**KNOXVILLE HISTORIC ZONING COMMISSION
STAFF REPORT - CERTIFICATE OF APPROPRIATENESS APPLICATION**

PROPERTY ADDRESS: 1802 Highland Ave 37916
DISTRICT: Fort Sanders NC-1

FILE NO.: 6-I-18-HZ

MEETING DATE: 6/21/2018
APPLICANT: Land Development Solutions; E J Baksa (Consultant)
LEVEL OF WORK: Level III. Construction of new primary building

1 EAST ELEVATION
 SCALE: 1/8" = 1'-0"

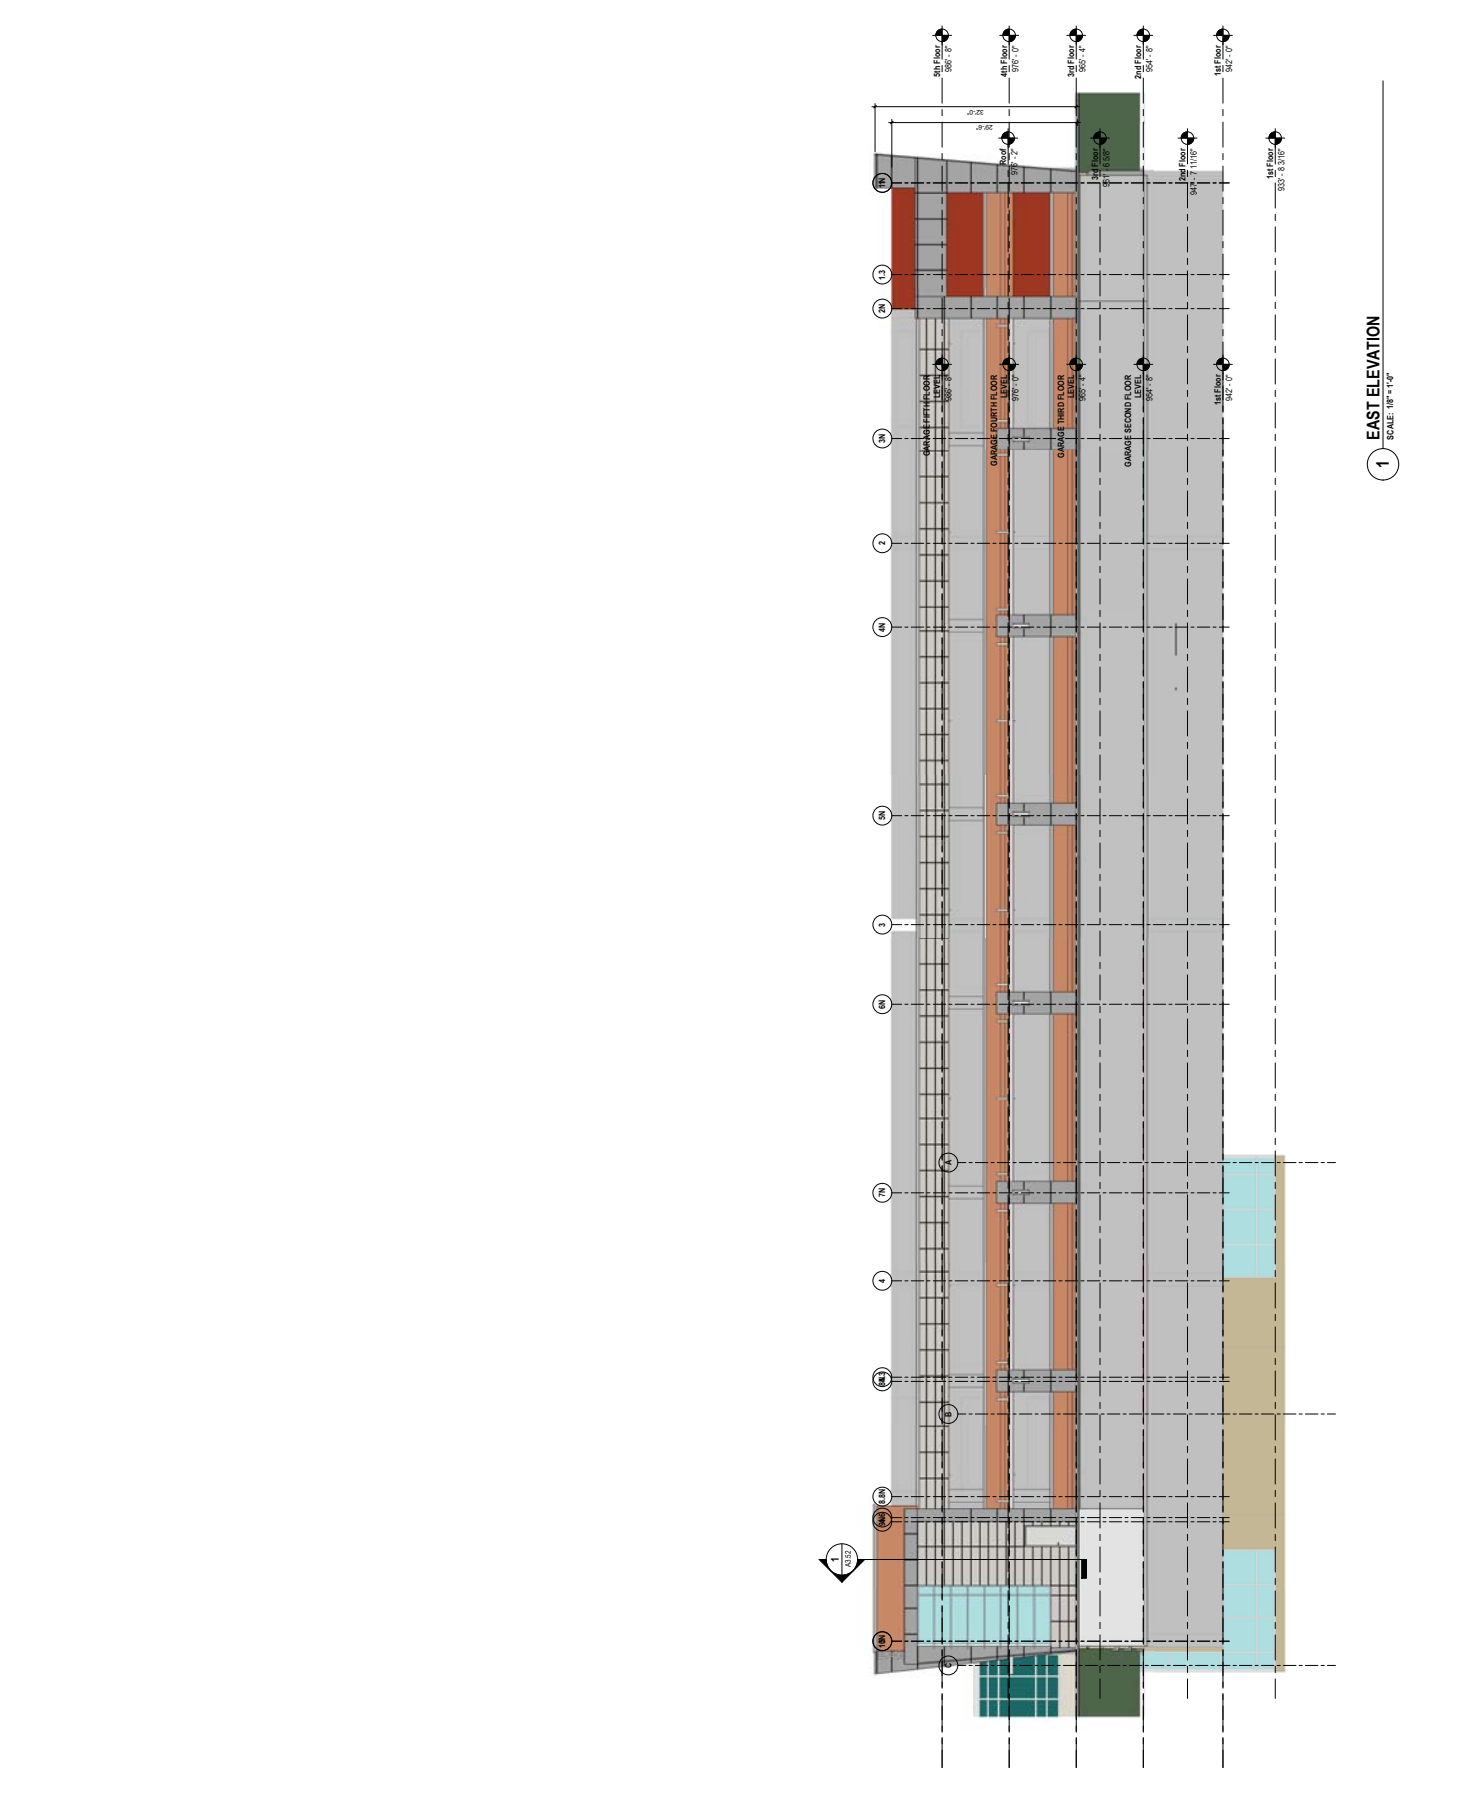
2. The pilasters along the street frontages are proposed to project a few inches as scaled on the drawings, and the overhanging metal canopies project about 4 feet; however, there are no projecting bays indicated. The design guidelines for Large-Lot Development recommend building bays that project out to 5 feet for 50% of the façade. These bays should be articulated to have vertical orientation to be compatible with the character of this urban neighborhood.

3. The proposed facades are punctuated by pilasters at about ~ 27 feet on center. The design guidelines for Large-Lot Development recommend breaks (projections and recesses) in front facades of at least 6 feet wide and 5 feet deep.

7. The horizontal band openings are not compatible with the residential character of the buildings in the surrounding streetscapes. Vertically oriented windcows with metal framed divisions to breakdown the scale would be more compatible with the residential character of the surrounding development.

- 1) meets the design guidelines for projections and recesses at intervals that break up the facades;
- 2) employs vertical articulation through the top of the second level of the façade;
- 3) vertical openings with metal framing or grids to break down the size, rather than horizontal ribbon openings;
- 4) includes screening in the openings on both levels to reduce light overspill and views into the garage; and
- 5) meets the design guidelines for landscaping.
